**Department of Licensing and Regulatory Affairs**

**Final Report - Resubmittal Requested**

**Application Number: PR2023BCC-001595**

**Description : BLDG23-01596 Renovate Detroit Light Guard Armory**

**1 SITE PLAN**  
 X1 SCALE 1" = 40'

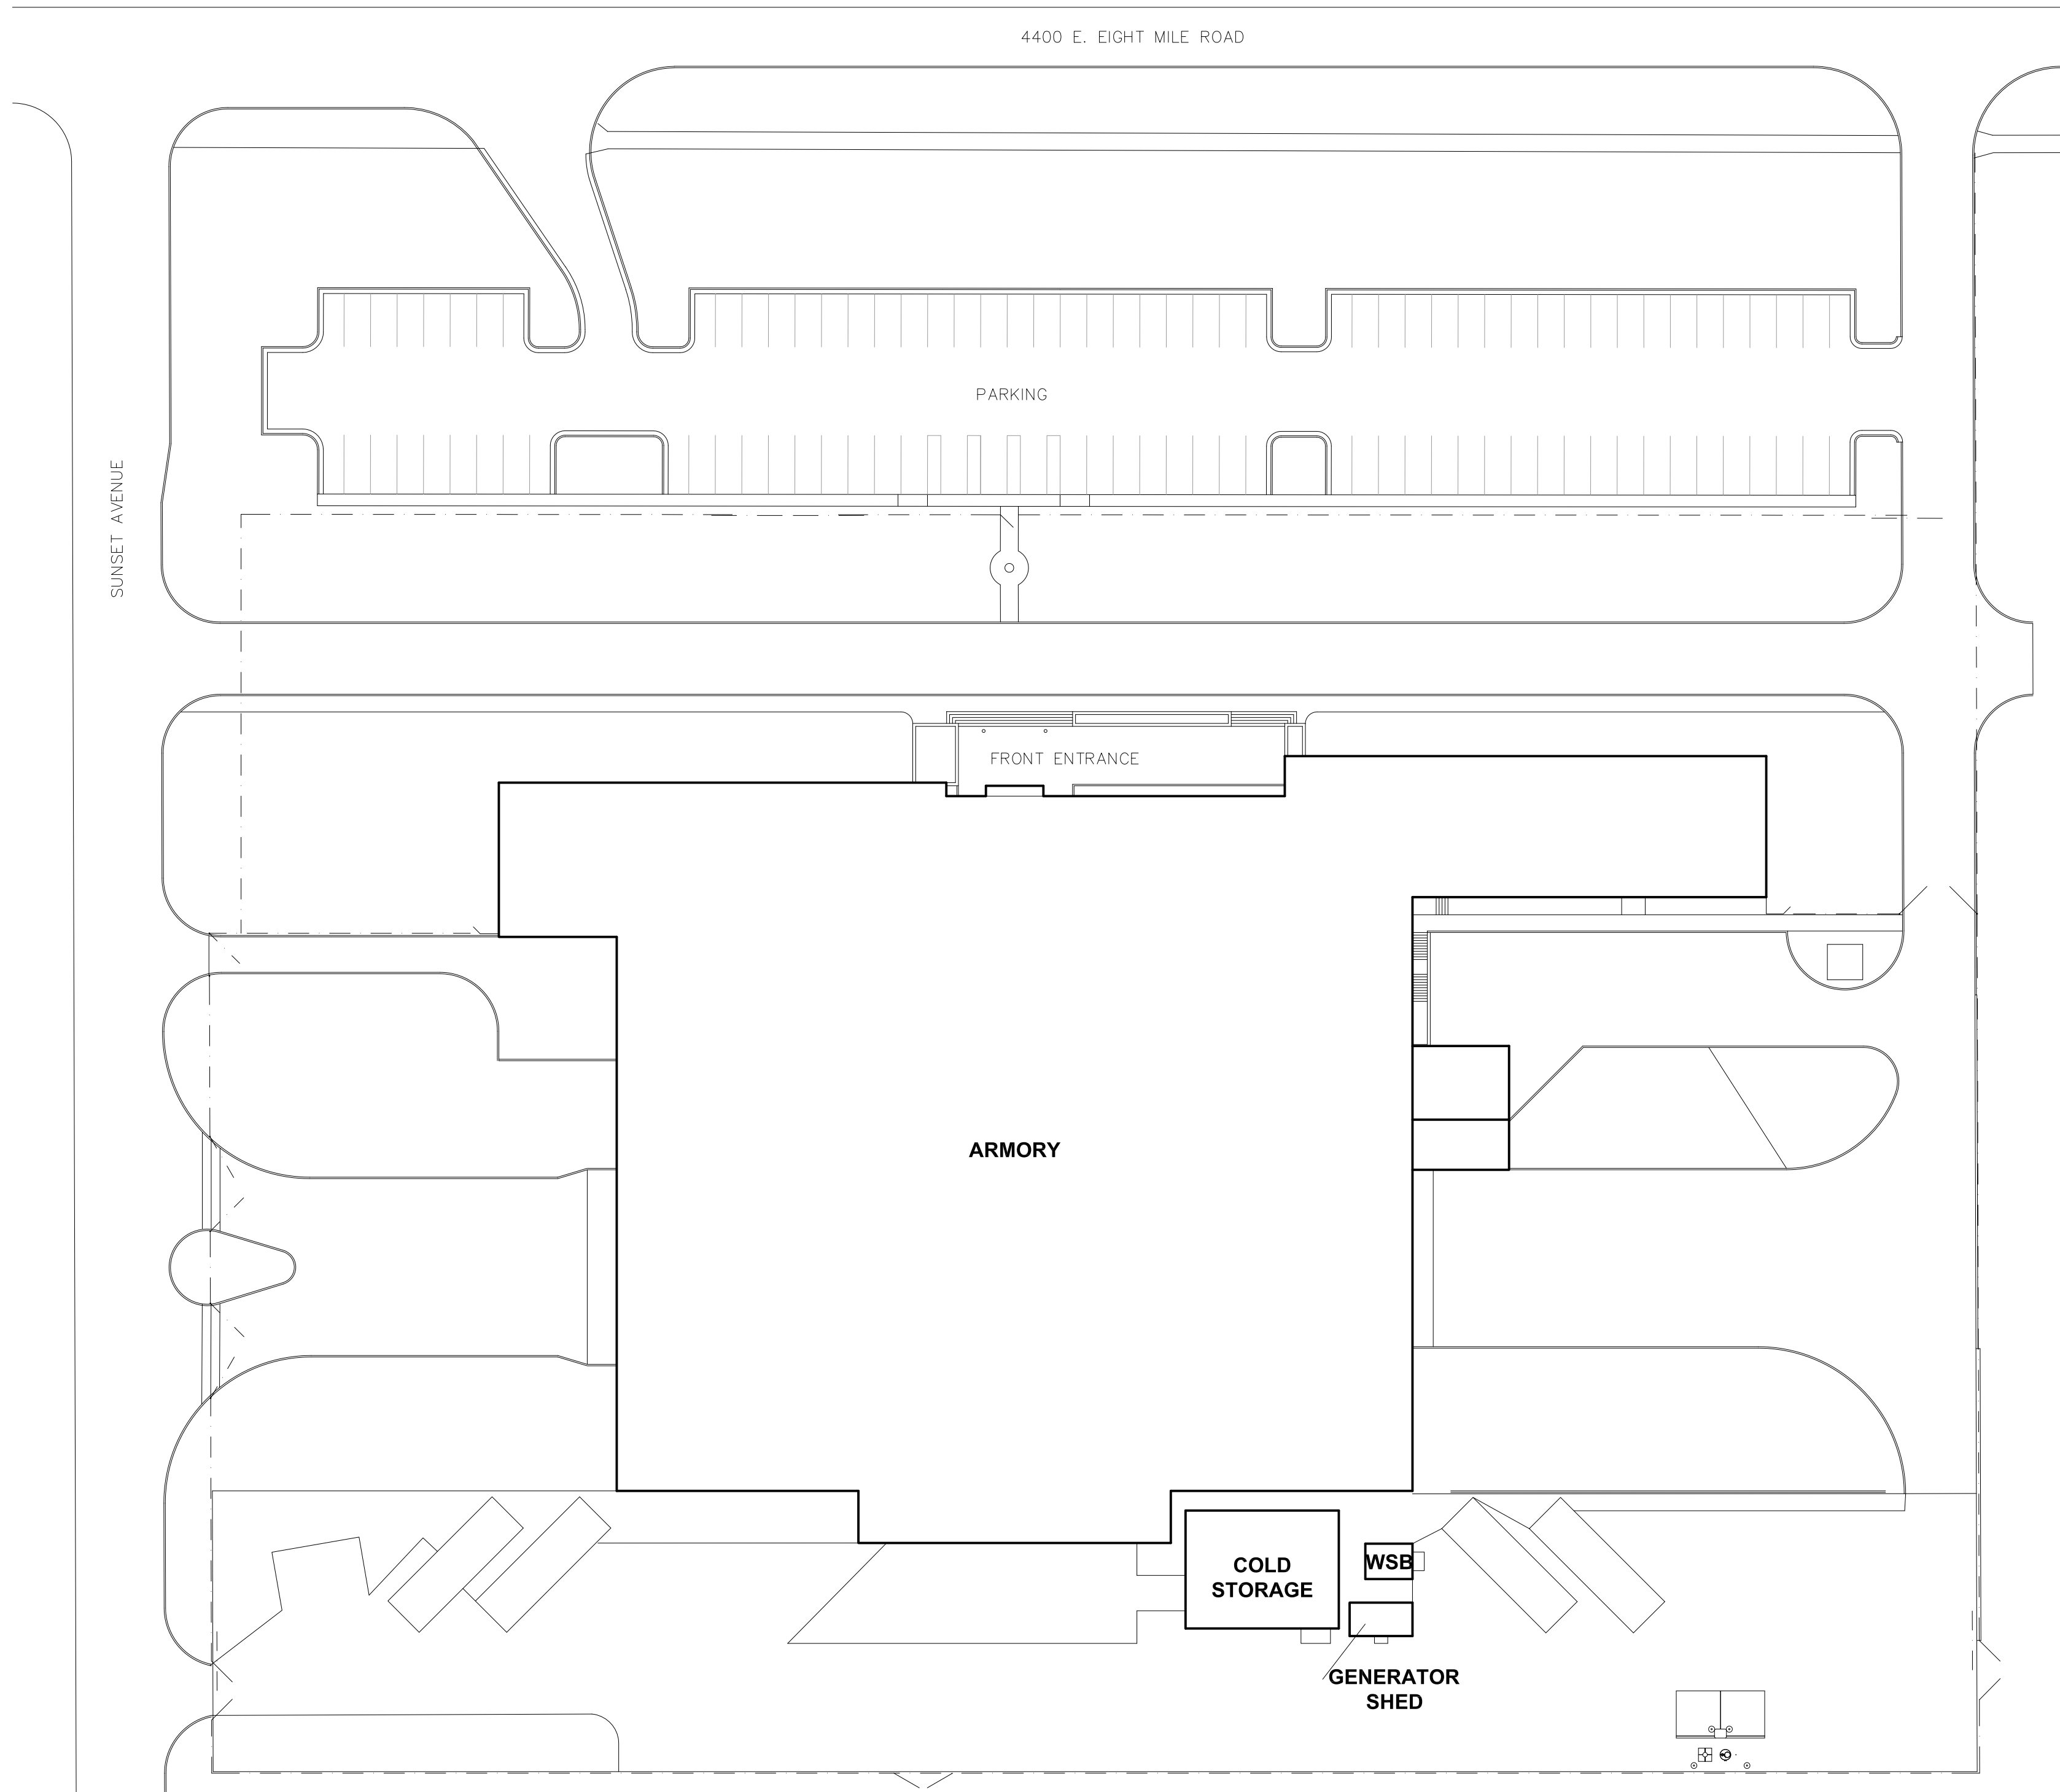
Comment ID	Page Ref	Reviewer : Department	Review Comments
1	X1	Kevin Oglesbee : Building	MRHB2015 - 1505.2 Maintenance of means of egress. Required means of egress shall be maintained at all times during construction, demolition, remodeling or alterations and additions to any building.
2	E2	Neil Pline : Electrical	NEC, Section 406.9 - Receptacles in wet and damp locations are required to be a listed weather resistant type. Provide for GFCI's in locker room.
5	E10	Neil Pline : Electrical	NEC, Section 700.4 - An emergency system shall have adequate capacity and rating for all loads to be operated simultaneously. Generator is undersized. Provide all breaker sizes on generator.

**2 PARTIAL NEW FIRST FLOOR PLAN  
P2 NEW PLUMBING - DOMESTIC WATER**  
SCALE 1/4" = 1'-0" (ALSO SHOWS THE PIPING REFLECTIVE CEILING PLAN OF THE BASEMENT)

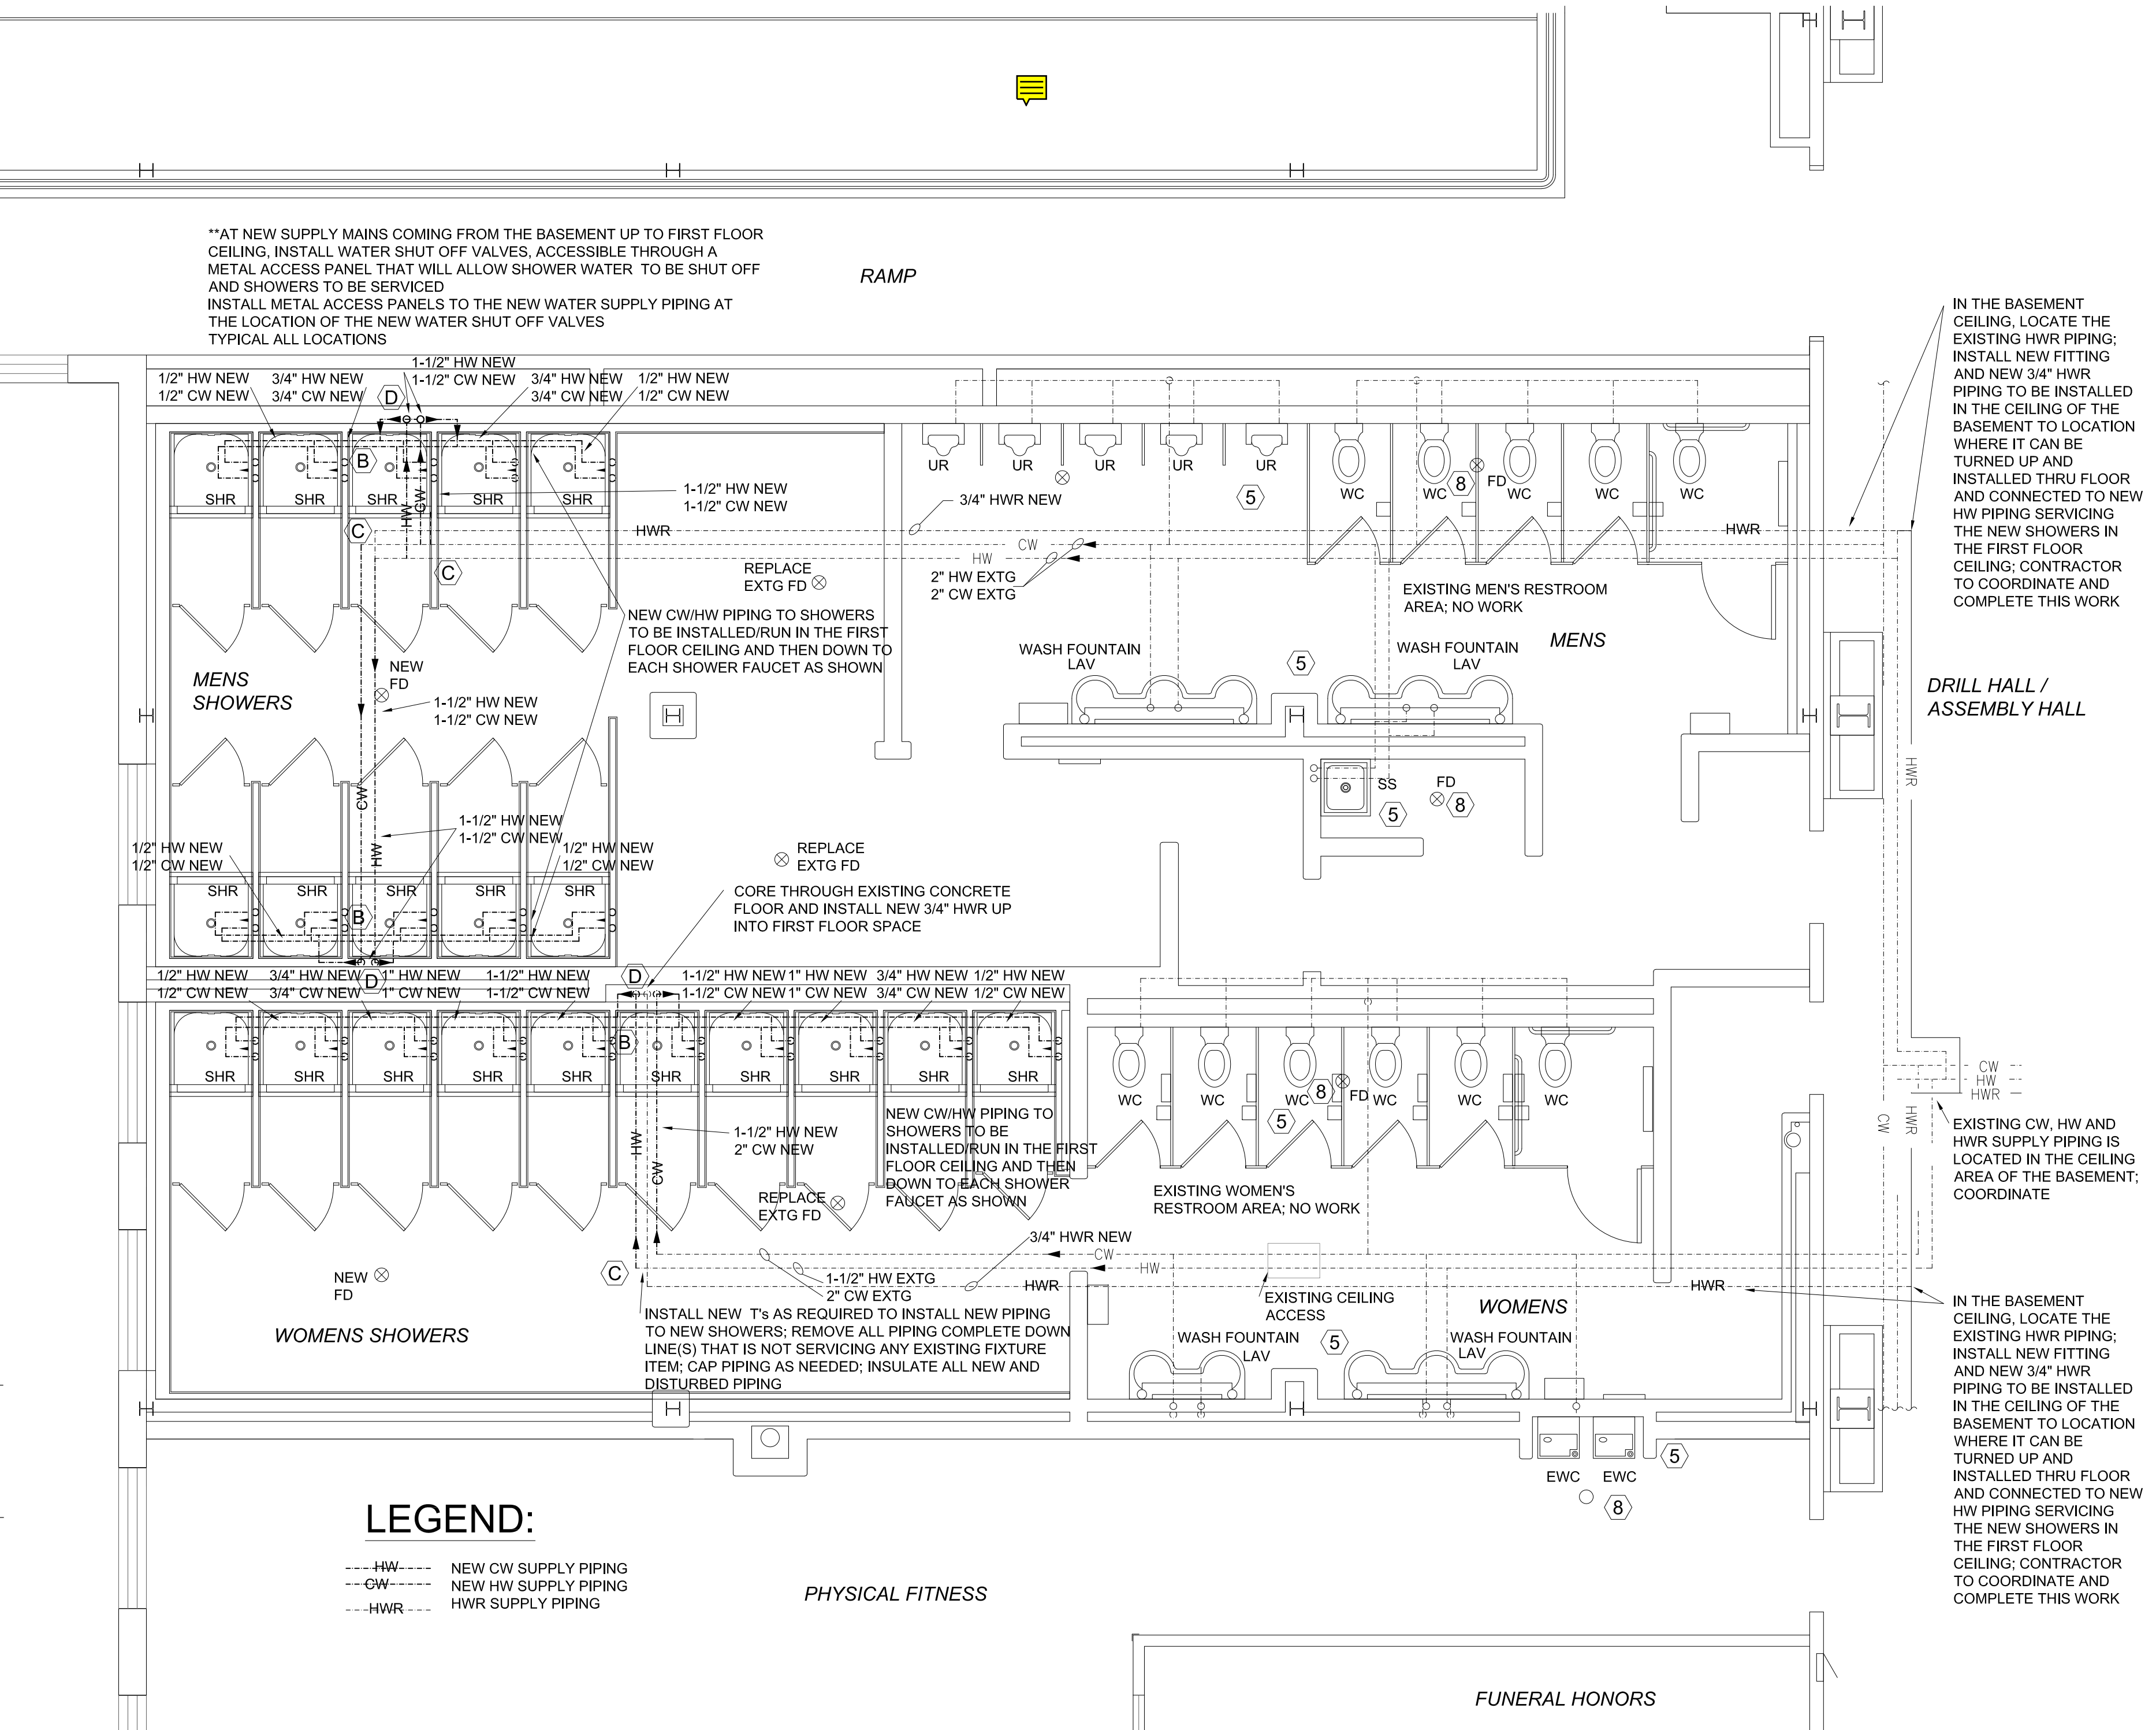
Comment ID	Page Ref	Reviewer : Department	Review Comments
14	P2	Allon Robbins : Plumbing	<p>MPC, Section 405.3.5 - Each urinal utilized by the public or employees shall occupy a separate area with walls or partitions to provide privacy. The horizontal dimension between walls or partitions at each urinal shall be not less than 30 inches (762 mm). The walls or partitions shall begin at a height not greater than 12 inches (305 mm) from and extend not less than 60 inches (1524 mm) above the finished floor surface. The walls or partitions shall extend from the wall surface at each side of the urinal not less than 18 inches (457 mm) or to a point not less than 6 inches (152 mm) beyond the outermost front lip of the urinal measured from the finished backwall surface, whichever is greater. Exceptions: 1) Urinal partitions shall not be required in a single-occupant or family/assisted-use toilet room with a lockable door. 2) 2. Toilet rooms located in child day care facilities and containing two or more urinals shall be permitted to have one urinal without partitions.</p>

SHEET MECHANICAL PLAN **M2.0**

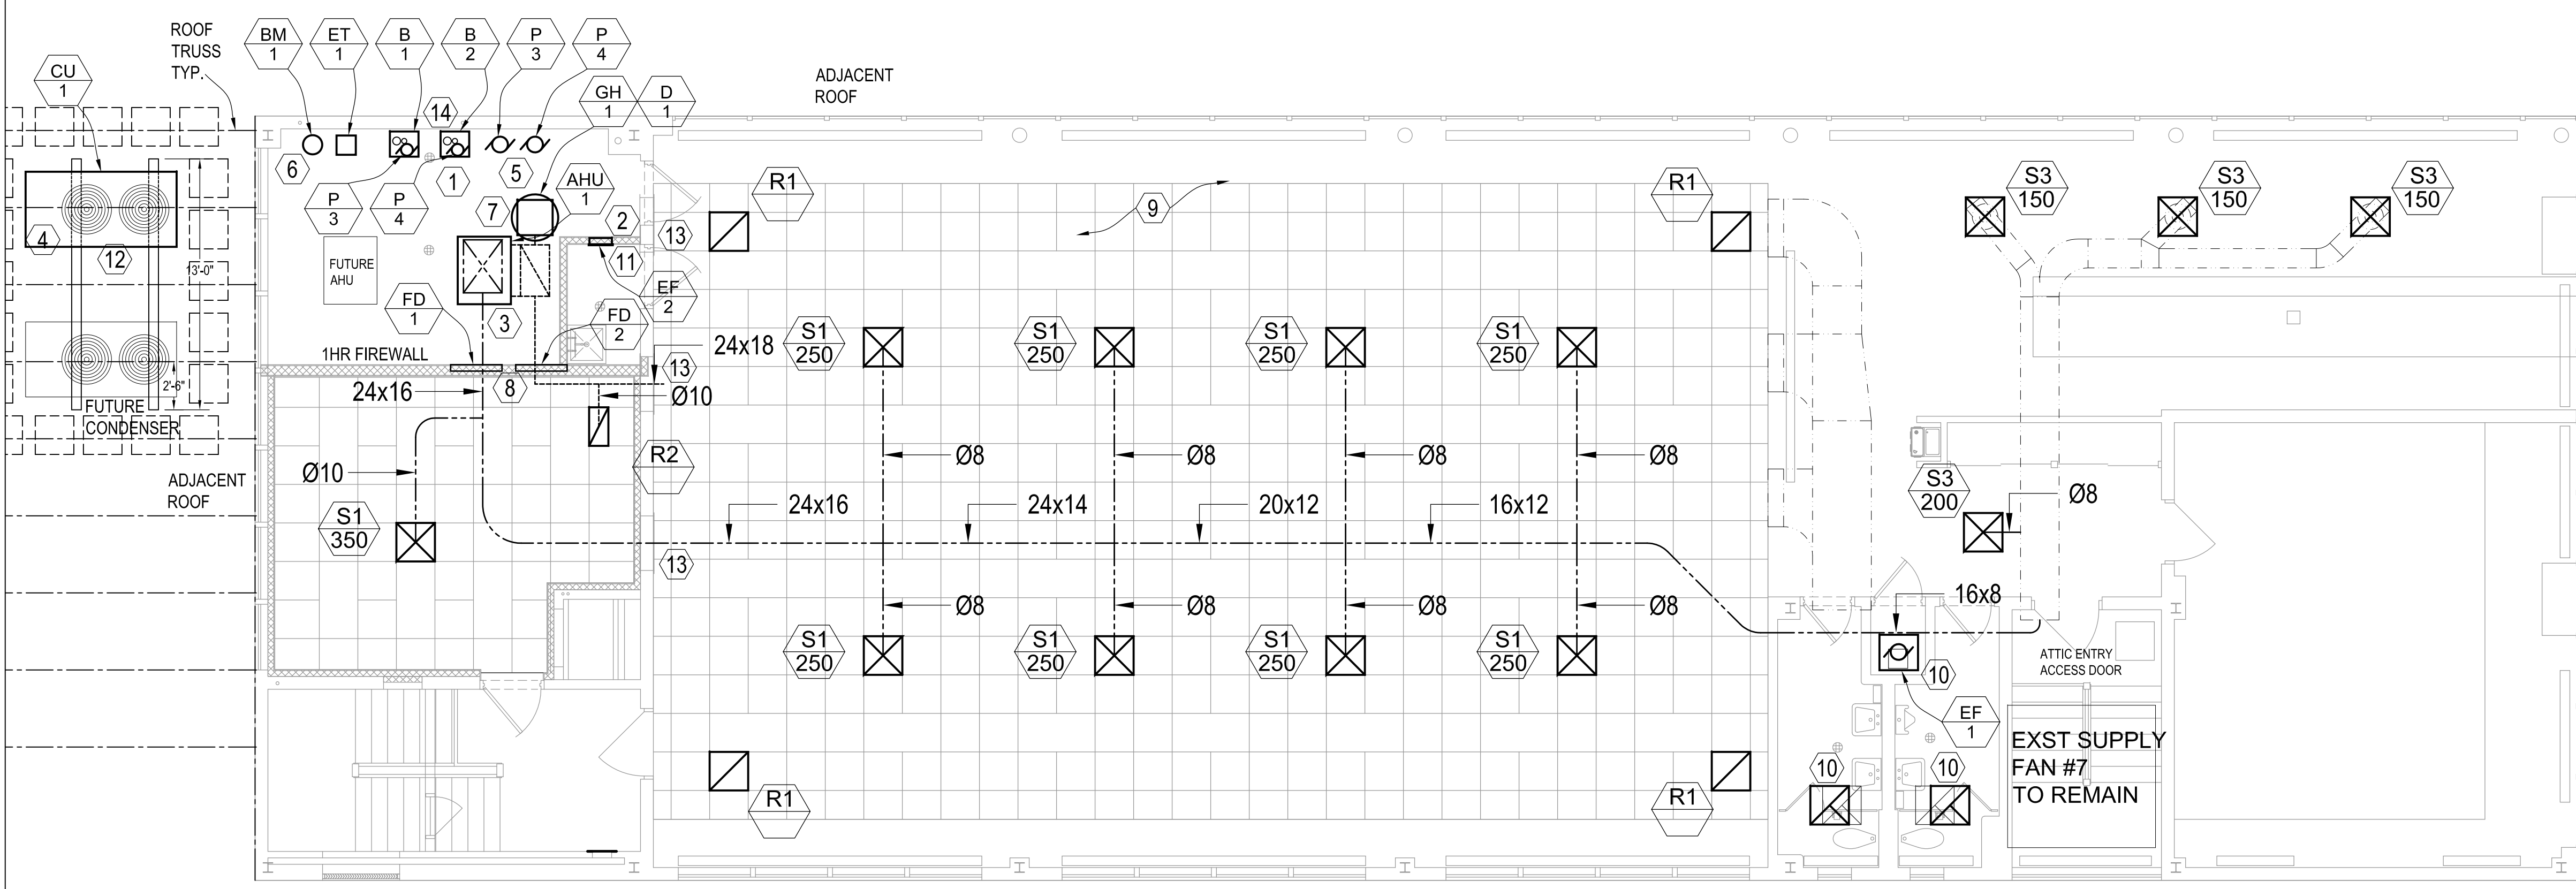
12	M2	Daniel Morris : Mechanical	MMC, Section 1005.2 - Potable water supply. The water supply to all boilers shall be connected in accordance with the International Plumbing Code.
13	M2	Daniel Morris : Mechanical	MMC, Section 1004.1 - Standards. Boilers shall be designed, constructed and certified in accordance with the ASME Boiler and Pressure Vessel Code, Section I or IV. Controls and safety devices for boilers with fuel input ratings of 12,500,000 Btu/hr (3,662,500 W) or less shall meet the requirements of ASME CSD-1. Controls and safety devices for boilers with inputs greater than 12,500,000 Btu/hr (3,662,500 W) shall meet the requirements of NFPA 85. Packaged oil-fired boilers shall be listed and labeled in accordance with UL 726. Packaged electric boilers shall be listed and labeled in accordance with UL 834. Solid-fuel-fired boilers shall be listed and labeled in accordance with UL 2523.
